WARNER'S POND RESTORATION PROJECT

PROJECT #2243

ADDENDUM #1

Re: **Contract No. 2243 – Warner's Pond Restoration Project
Addendum #1**

TOWN OF CONCORD
WARNER'S POND RESTORATION PROJECT
 CONCORD, MASSACHUSETTS
CROSS SECTIONS

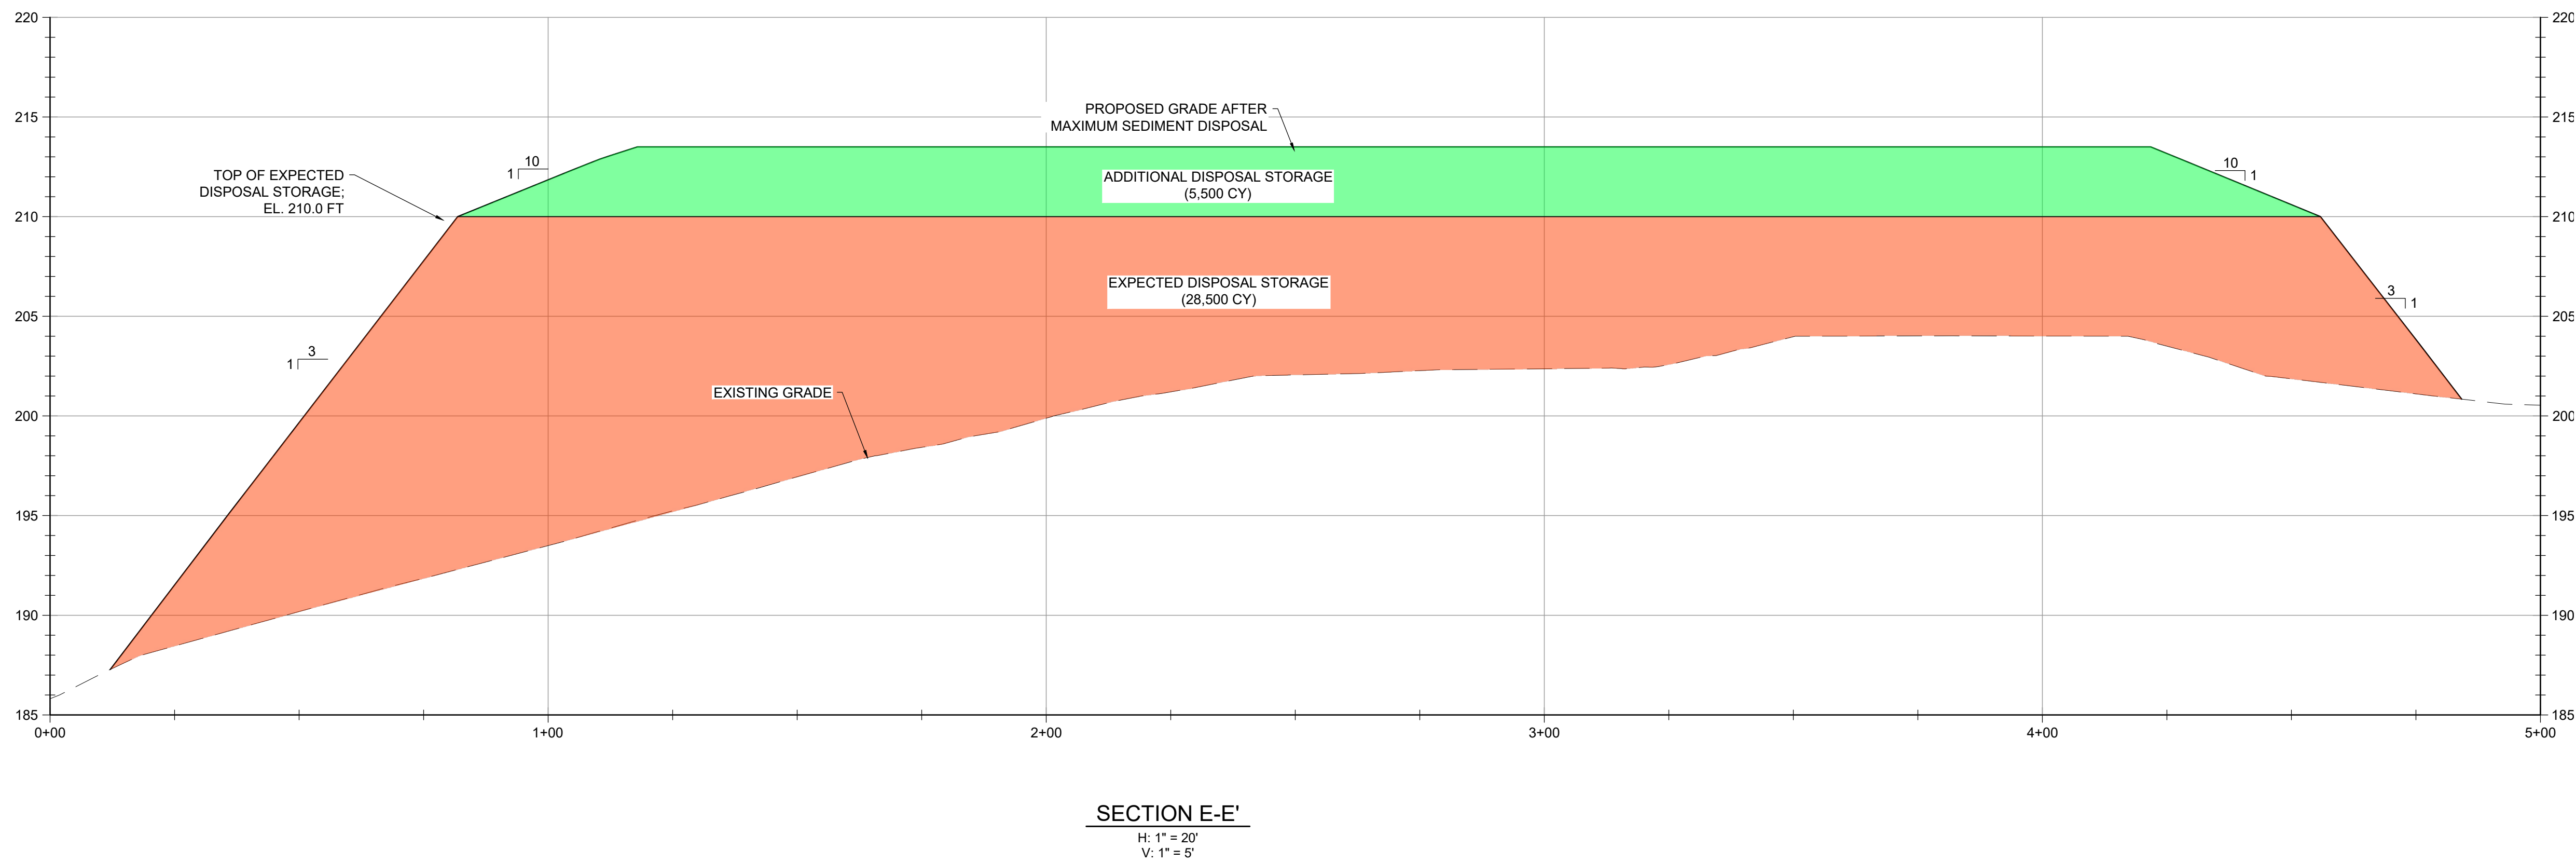
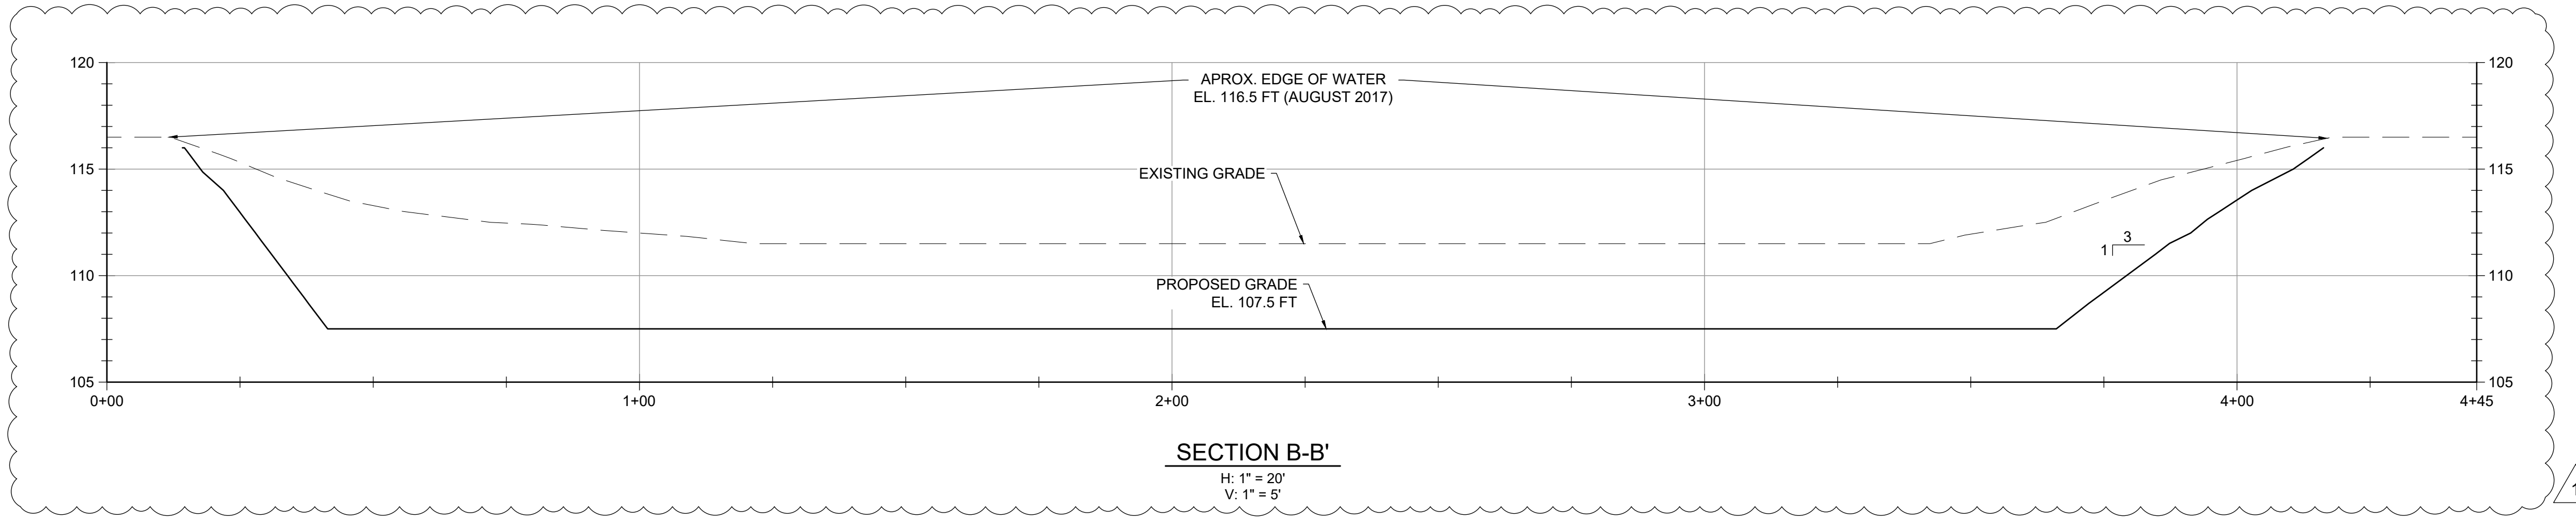
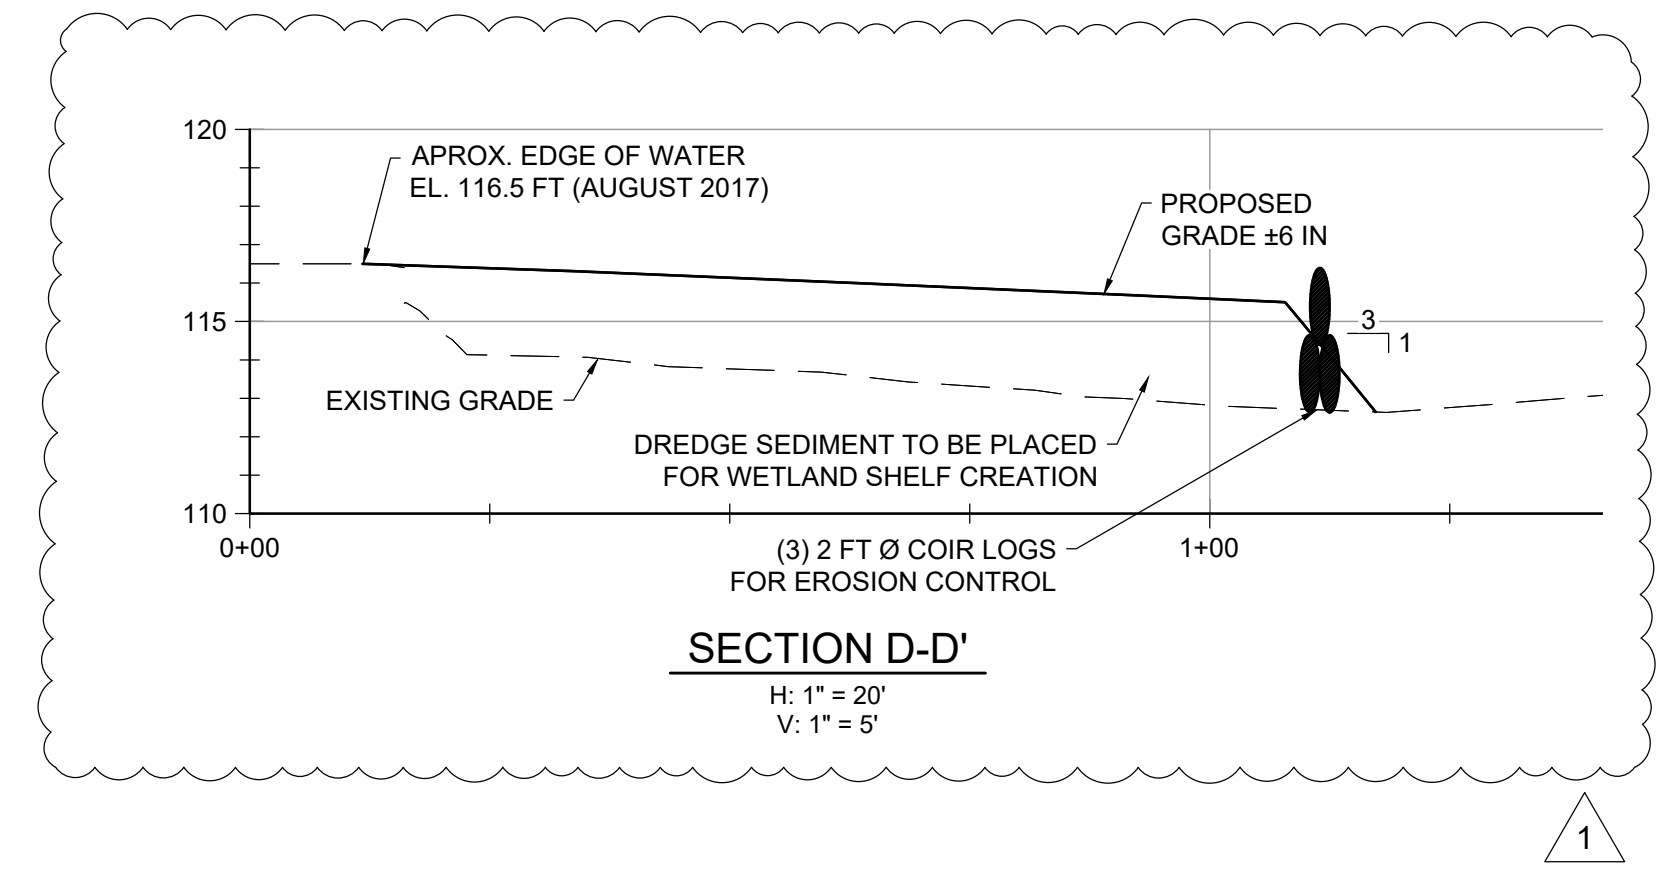
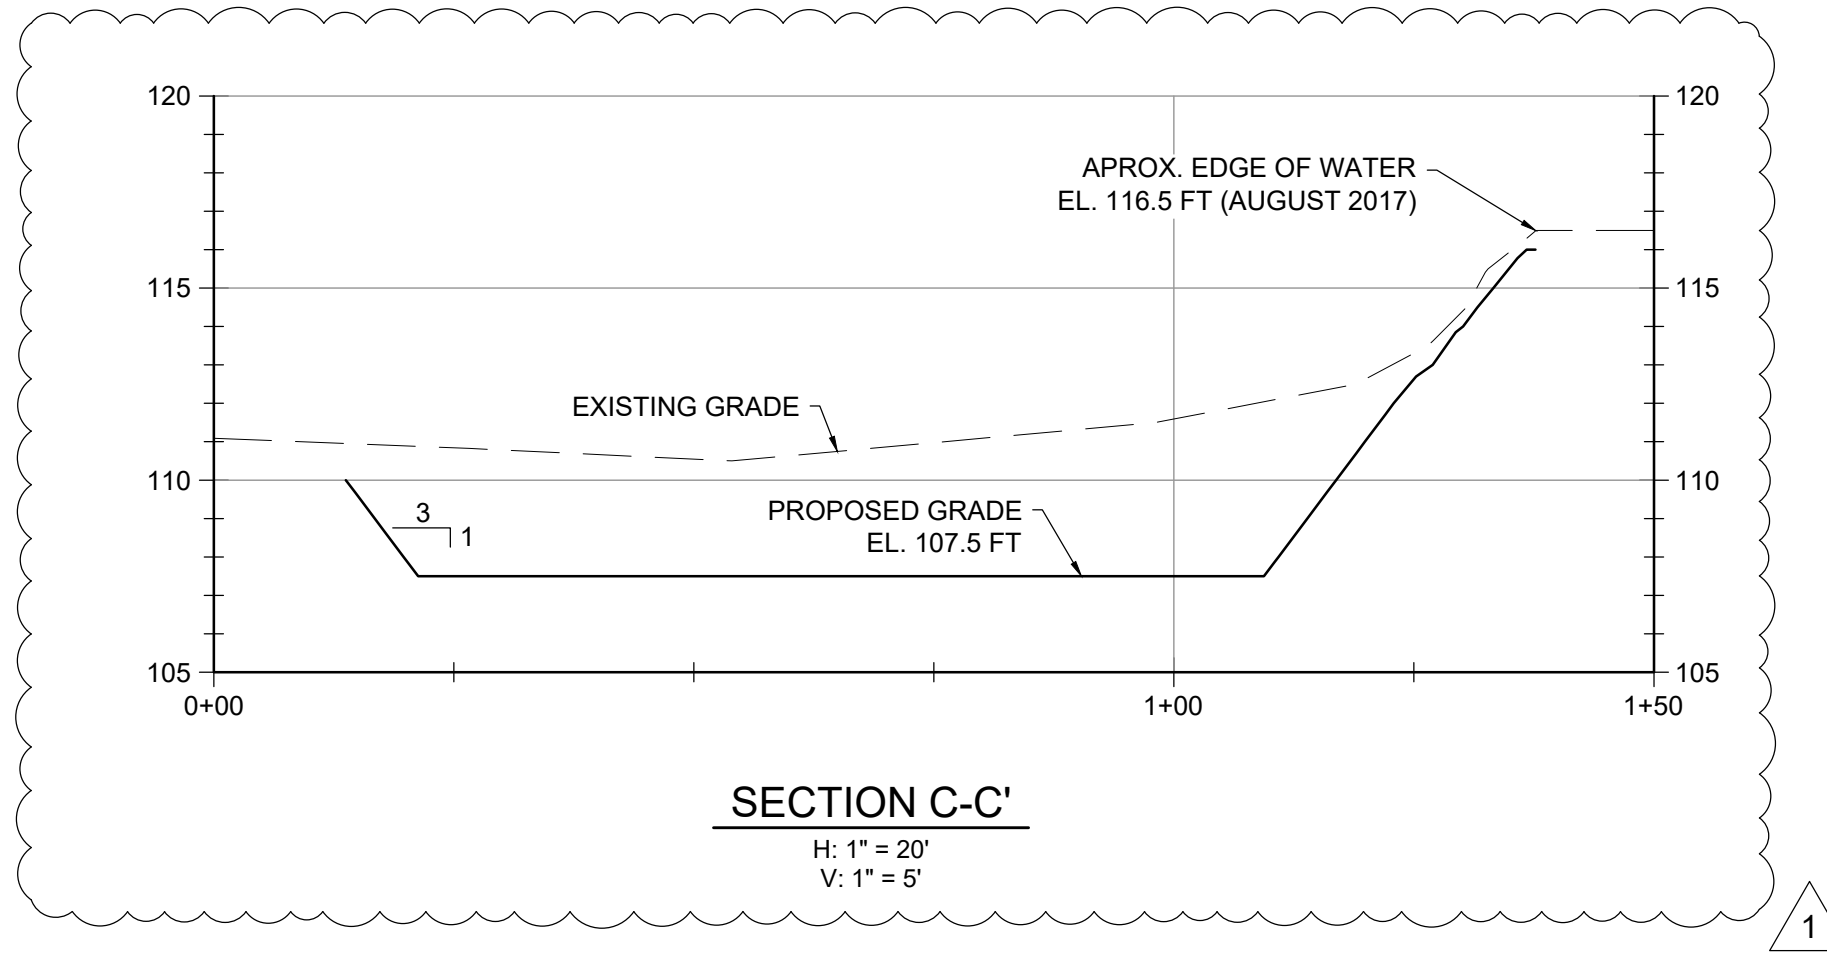
- a. Based on drawing Section D-D it looks like the core log is to be installed underwater. Is this correct?

20. Question: Please reference Drawing C-104 and C-301 showing Coir Logs to be installed at the perimeter of the Wetland Shelf. Please confirm that the Town desires these to be placed under water.

33. Question: Is the 1' of over dredge paid for?

Response: Yes. Please see updated coir log detail on Sheet C-301.

Response: The wetland shelf must be constructed within the footprint indicated in the project plans and the surface area of the wetland shelf surface must be substantially as indicated on the project plans. Therefore, the side slopes of the wetland shelf will be required to be substantially as indicated on the project plans. Refer to the updated Section D-D' detail on Sheet C-301.

Response: There is no over dredge allowance for the project. Sheet C-301 has been revised to remove over dredge surface. The Dredging section has been revised to remove references to over dredge allowance.
